Access Compliance Report Public Rights-of-Way (Curb Ramps)

Intersection ID: 27431 Main Street: BALLANTYNE_COMMONS_PY Cross Street: RUSHMORE_DR Location: NW
ADA ID: EF287E30799B Ramp Type: Perp Initial Pass/Fail: Fail Overall Compliance: No Severity Score: 10

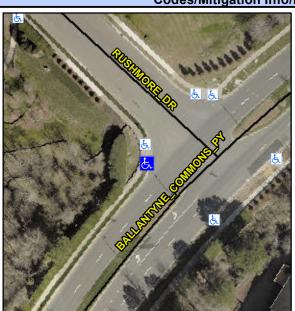
Not Found, R304.5.1, R304.5.3

Field Measurements/Component Compliance						
Compl	iance Description	Data	Comp	iance	Description	Data
N/A	Ramp Length (in)	110.0	Yes	Ramp	Slope (%)	6.8
No	Ramp Width (in)	43.0	No	Ramp	XSlope (%)	3.8
N/A	Flare Type LT	N/A	N/A	Flare	Type RT	N/A
N/A	Flare Slope LT (%)	N/A	N/A	Flare	Slope RT (%)	N/A
N/A	Flare Traversable LT?	N/A	N/A	Flare	Traversable RT?	N/A
N/A	Landing Length (in)	N/A	N/A	DWS	Provided?	N/A
N/A	Landing Width (in)	N/A	N/A	DWS	Contrast?	N/A
N/A	Landing Slope (%)	N/A	N/A	DWS	Length (in)	N/A
N/A	Landing X Slope (%)	N/A	N/A	DWS	Full Width?	N/A
N/A	Landing Curb? (Y/N)	N/A	N/A	DWS	Offset (in)	N/A
N/A	Shared Landing?	N/A				
N/A	Gutter Ponding?	N/A	N/A	Gutte	r Slope (%)	N/A
N/A	Gutter Lip Ht (in)	N/A	N/A	Gutte	r X Slope (%)	N/A
N/A	Painted X Walk1?	No	N/A	Paint	ed X Walk2?	N/A
	X Walk 1 Direction	To SE		X Wa	lk 2 Direction	N/A
N/A	X Walk 1 Width (in)	N/A	N/A	X Wa	lk 2 Width (in)	N/A
	X Walk 1 Slope (%)	1.2		X Wa	lk 2 Slope (%)	N/A

Remove & Replace Entire Ramp.
